**CHANGE ORDER NUMBER - 1**

Project: <b>Veterans Memorial Complex Parking Lot Improvements</b> Owner: <b>Brick Township Board of Education</b> Contractor: <b>C.J. Hesse, Inc.</b> <b>25 1st Avenue, Atlantic Highlands, NJ 07716</b>	Change Oder No.: <b>1</b>  Change Order Date: <b>7/25/2017</b>
--	--

ELECTRICAL SITE  
DEMOLITION PLAN

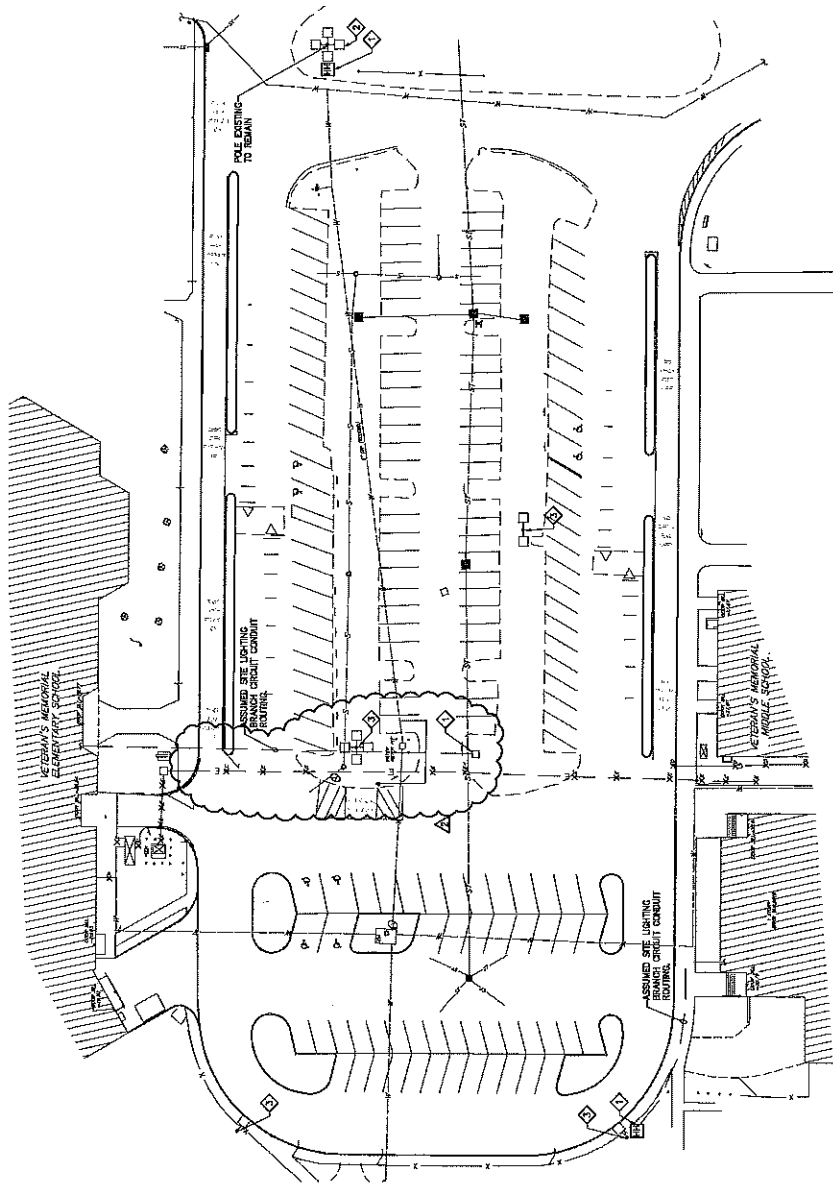
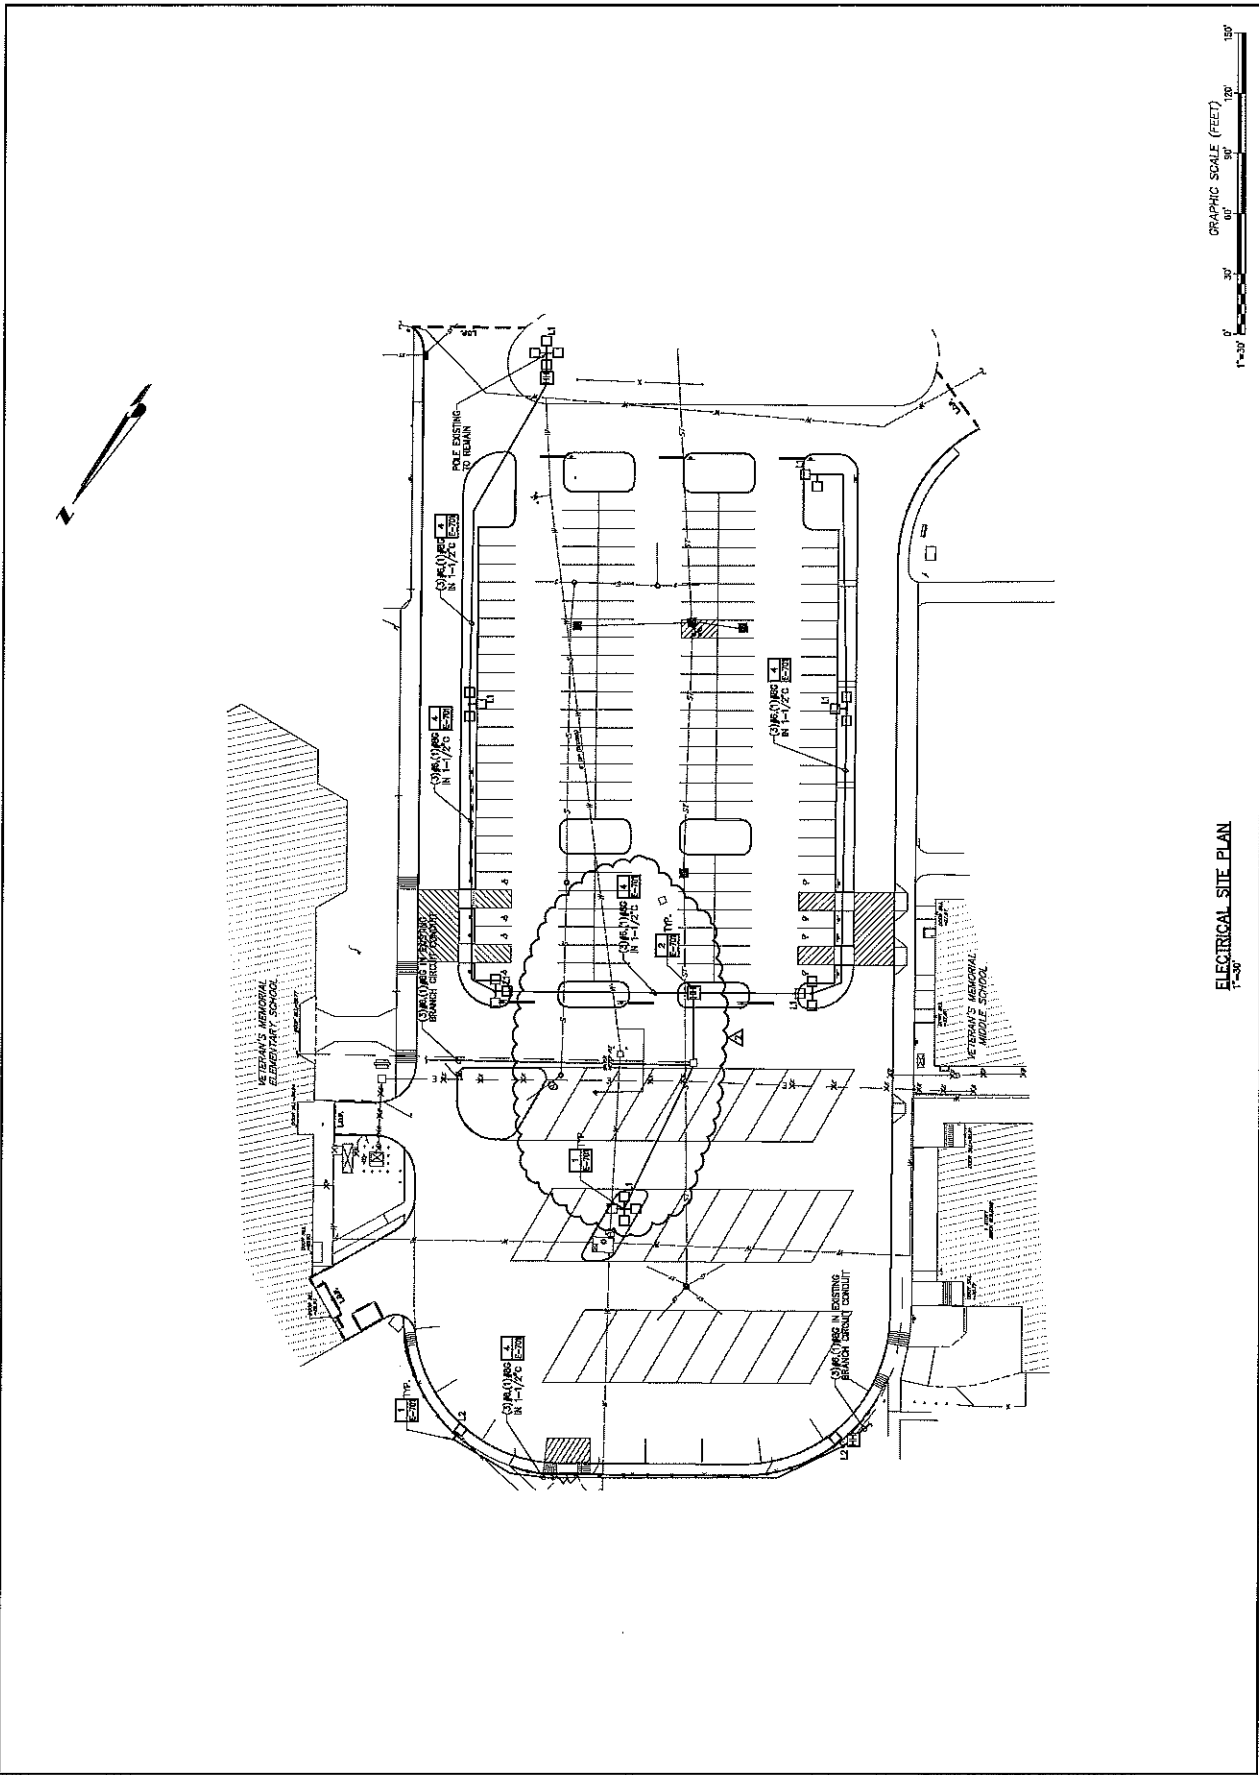
**Reason:** The existing electrical handhole shown on the contract drawings was to be abandoned since it was part of the existing lighting circuit for the parking lot that was no longer required. The contractor's electrician found that the source of the existing wiring inside could not be verified. With no record drawings or information from the school regarding the existing wiring, it was determined that the handhole could not be abandoned. However, the existing structure was not traffic rated and therefore needs to be reconstructed. A new structure was designed to span the existing structure and this was utilized as the new connection point. A proposed handhole was eliminated and the existing handhole did not need to be removed providing some credits. See the attached revised contract drawings with scope changes.
